ITEM 8. DEVELOPMENT APPLICATION: 511-515 BOTANY ROAD ZETLAND**FILE NO: D/2013/1947****DEVELOPMENT APPLICATION NO: D/2013/1947****SUMMARY****Date of Submission:** 13 December 2013**Applicant:** Lateral Estate Pty Ltd**Architect:** Candalepas Associates**Developer:** Lateral Estate Pty Ltd**Owner:** Korifi Pty Ltd and Petao Pty Ltd**Cost of Works:** \$79,419,120

Proposal Summary: The proposal comprises the demolition of existing structures, staged construction of 3 mixed use buildings between 3 and 9 storeys containing 308 residential apartments, 1 ground and mezzanine floor retail space, a single 2 level basement car park.

Figure 17: Original DA submission (Building B – northern elevation)

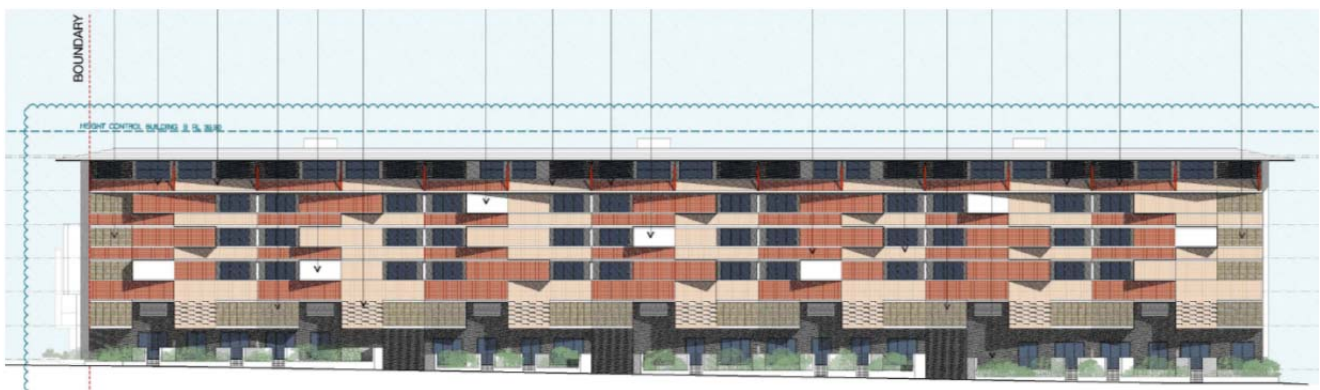
- Proposal Summary:**
(continued)
- The most significant concerns identified during the assessment related to the architectural quality of the buildings. Prior to revisions being made it was not considered that the proposal satisfied provisions for design excellence.

- The proposal was recently amended with modifications to the building expression, materials and finishes that have greatly improved the visual interest and adequately addressed the earlier concerns around design excellence.
